# IRC - Building

## 2016 GROUP B PUBLIC COMMENT AGENDA

OCTOBER 19 - OCTOBER 25, 2016  
KANSAS CITY CONVENTION CENTER  
KANSAS CITY, MO

**FIGURE R301.2(3)**  
**Alternate Seismic Design Categories**

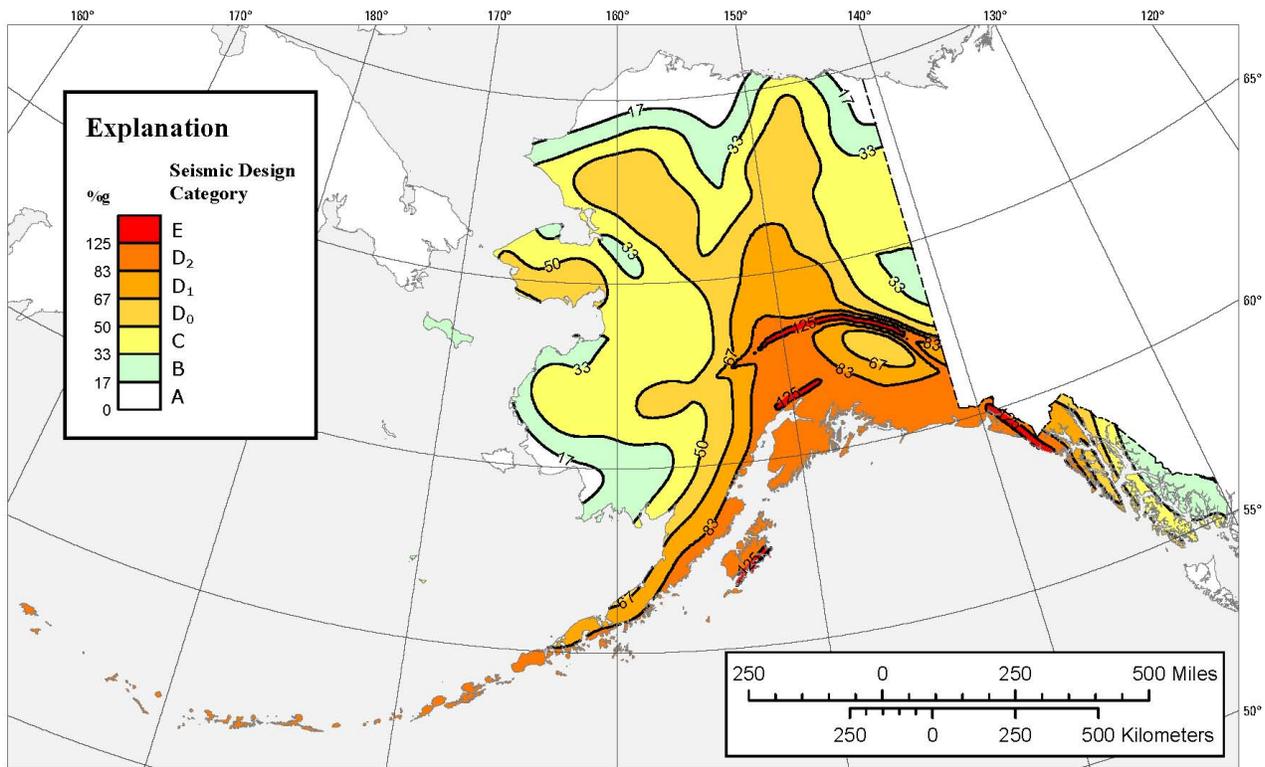
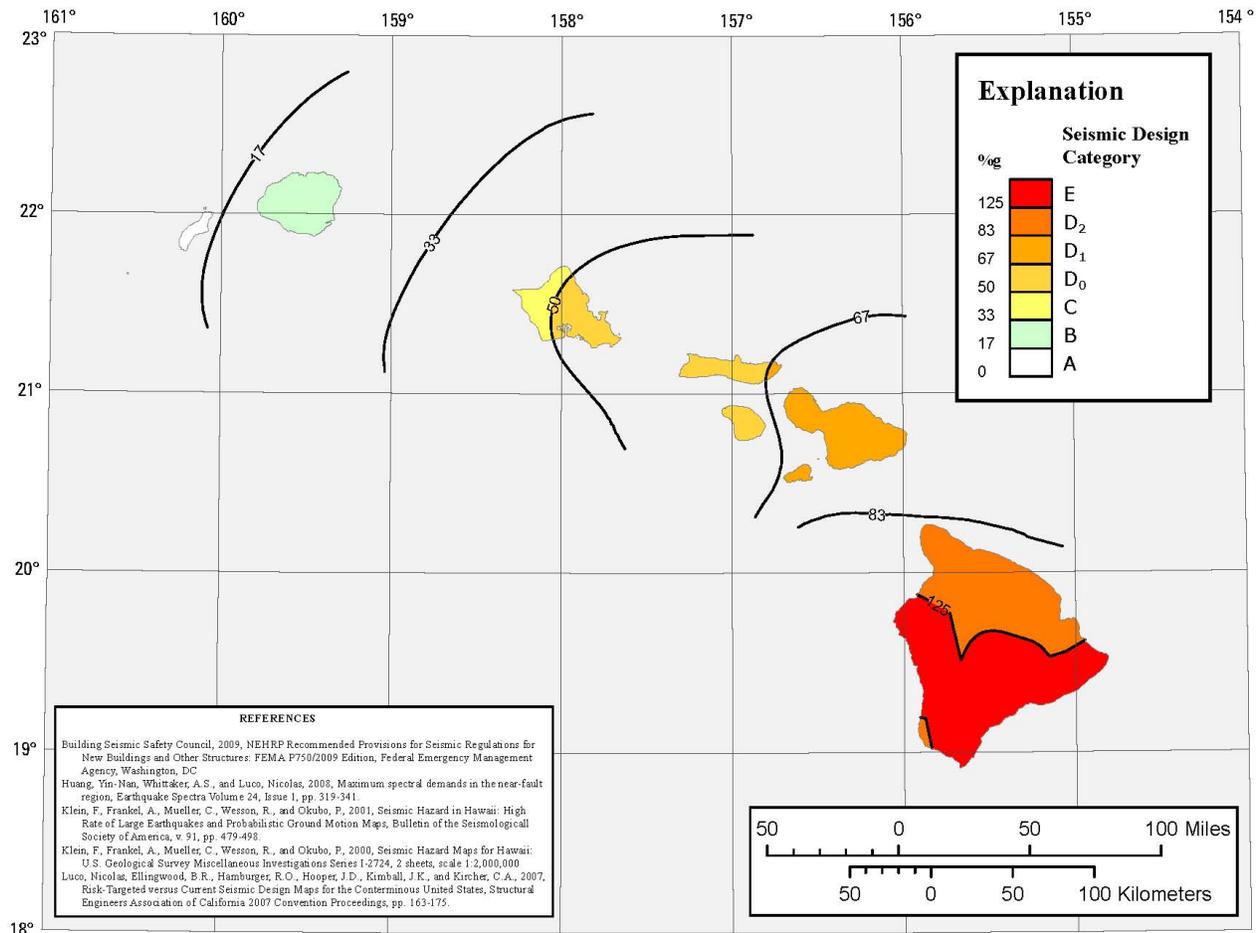
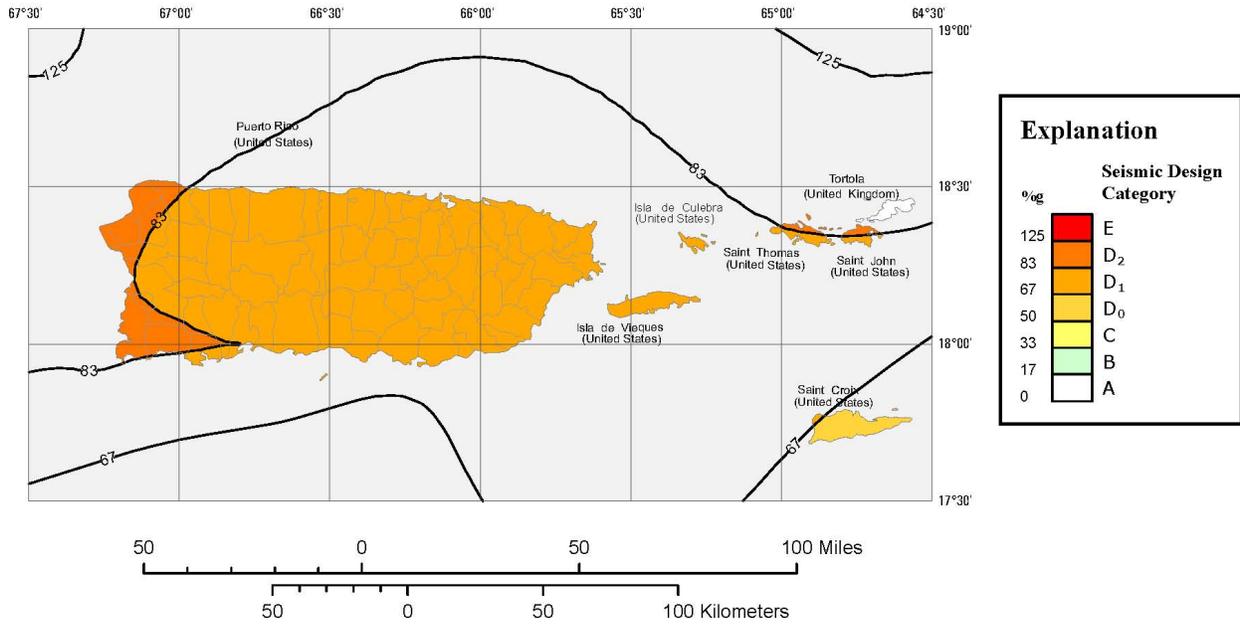
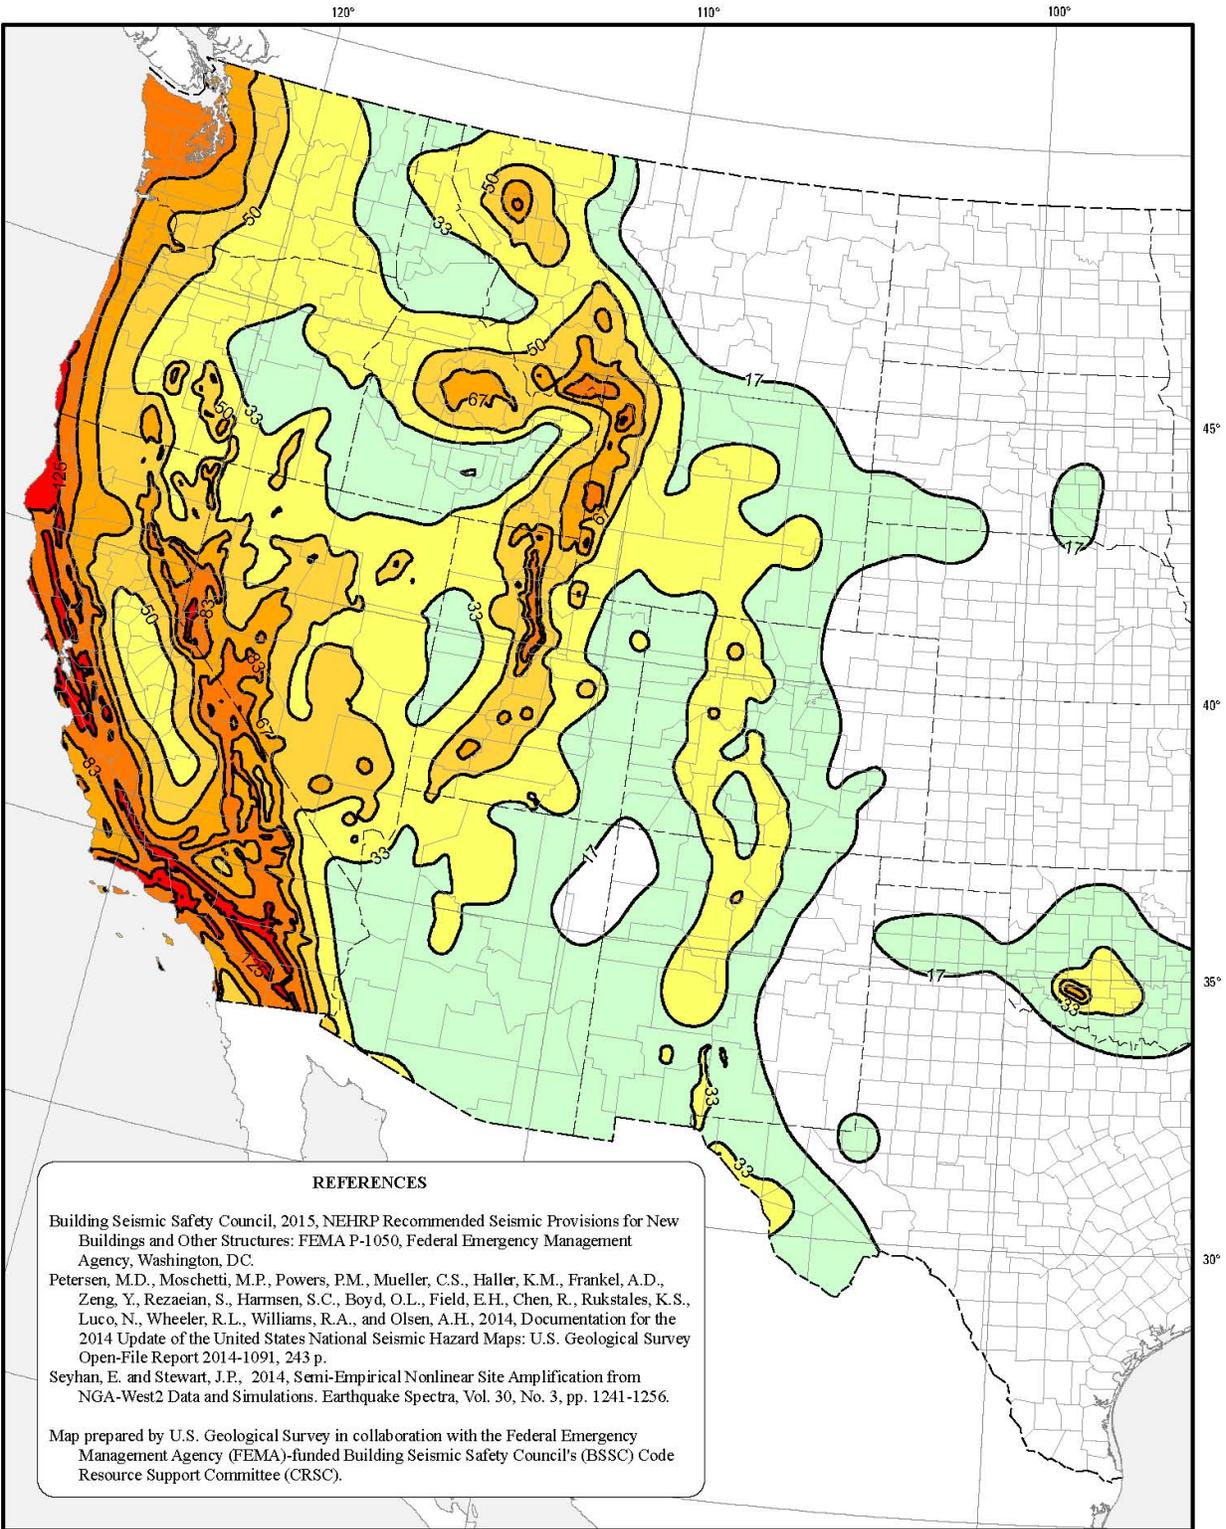
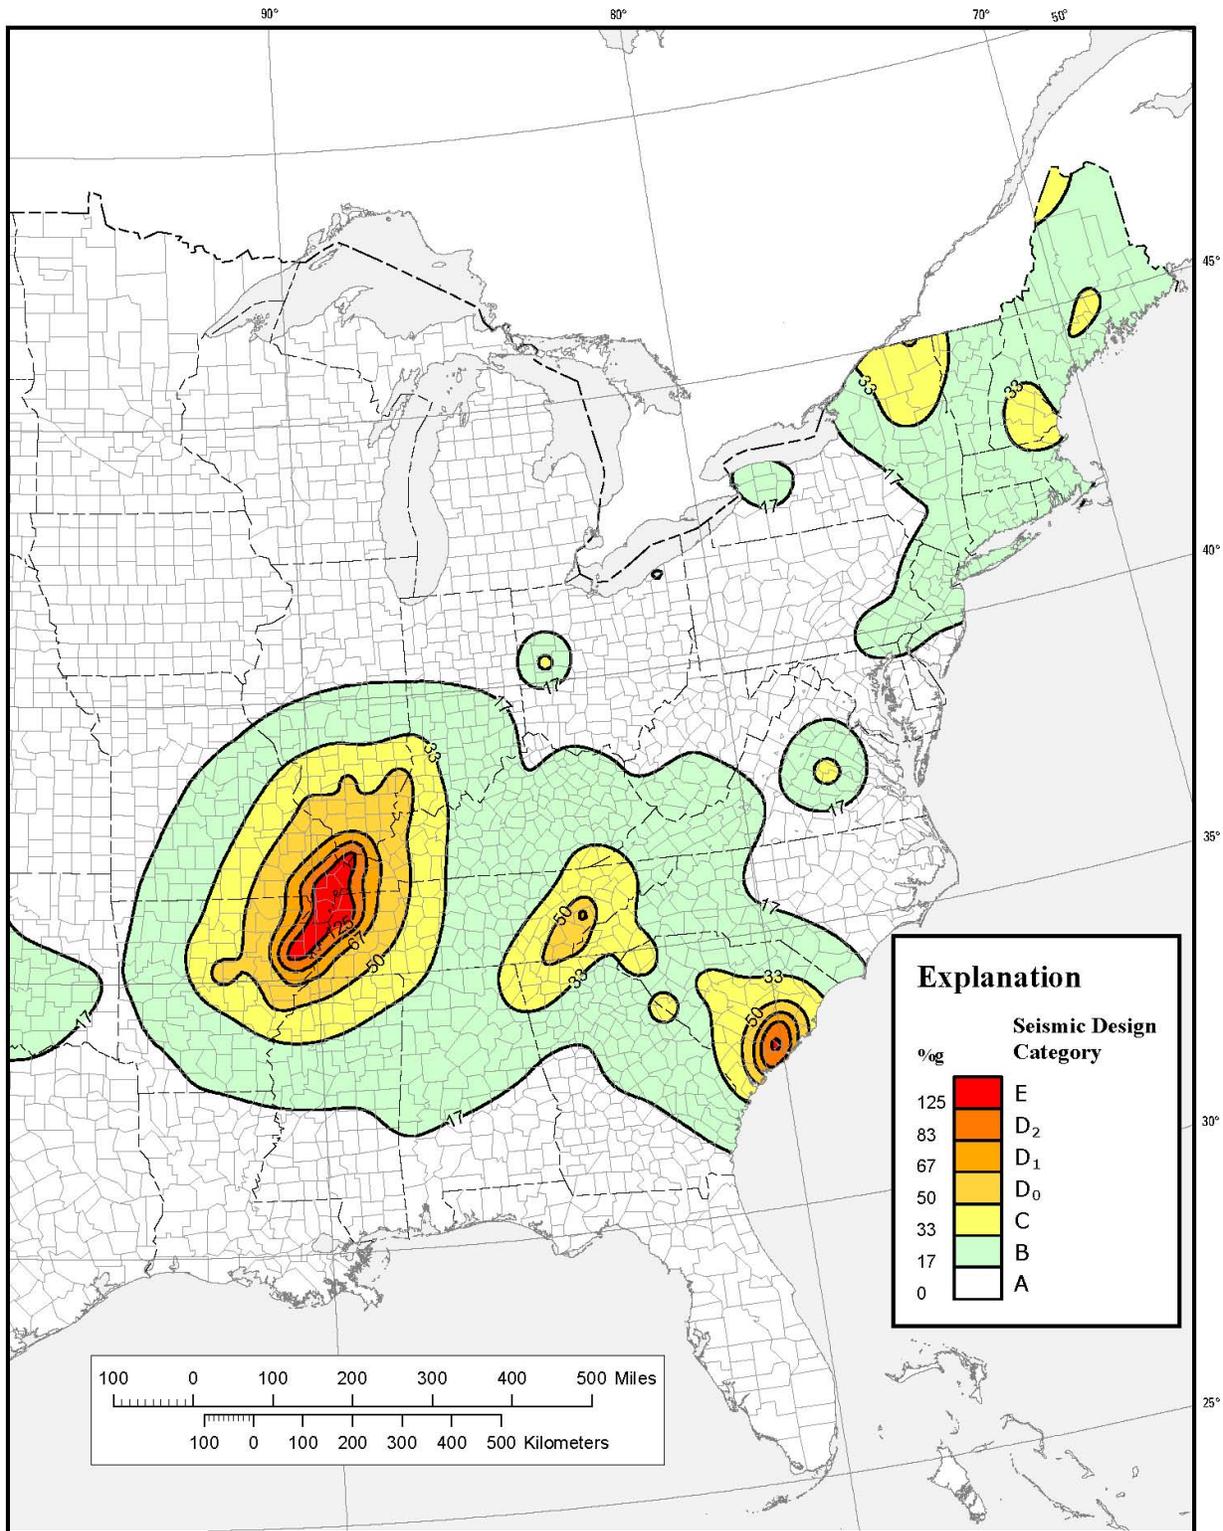
**Reason:** This proposal incorporates the most current seismic design maps prepared by the U.S. Geological Survey (USGS) in collaboration with the Federal Emergency Management Agency (FEMA) and the Building Seismic Safety Council (BSSC). A separate coordinated code change updates the seismic design maps in the IBC to be consistent with these IRC maps and the maps incorporated into ASCE 7-16. In addition to incorporating updated information on faults and ground motion attenuation, these maps incorporate revisions to site coefficients  $F_a$  and  $F_v$ . Technical reasons behind the revisions are documented in FEMA P-1050-1, 2015 Edition, Sections C11.4.2 (site classes), C11.4.3 (site coefficients), and C22 (seismic maps). Further documentation is provided in Seyhan and Stewart (2012, 2014) and Luco et al. (2015). As excerpted from FEMA P-1050-1, 2015 Edition, Section C11.4.3: "Motivation for the revisions to these site factors includes (Seyhan and Stewart, 2012): (1)

As in past versions, the IRC seismic design maps directly indicate Seismic Design Category for a given location. Development of the maps in the past incorporated a default assumption of a Site (soil) Class D, which provided the most conservative assignment of Seismic Design Category. For this update, (1) changes made to the site coefficients resulted in Site Class D no longer being the most critical site class at all spectral response acceleration levels, and (2) spectral response accelerations and resulting Seismic Design Categories increased at a number of locations when the most critical site coefficients were used. Because of these two effects, it is proposed that two sets of maps be adopted into the IRC. The updated R301.2(2) Seismic Design Category maps will provide the most conservative assignment of Seismic Design Category and can be used with any site/soil type within the limits of current IRC provisions. The new R301.2(3) Alternate Seismic Design Category maps will provide less conservative assignments of Seismic Design Category, permitted to be used when it can be determined that Site Class A, B or D is applicable. The building official may make a determination that use of the alternate maps is permitted, provided adequate information is available to determine site class, either on a community-wide basis or site-by-site basis. As in the past, alternate determination in accordance with the IBC is still permitted.

Add new text as follows:
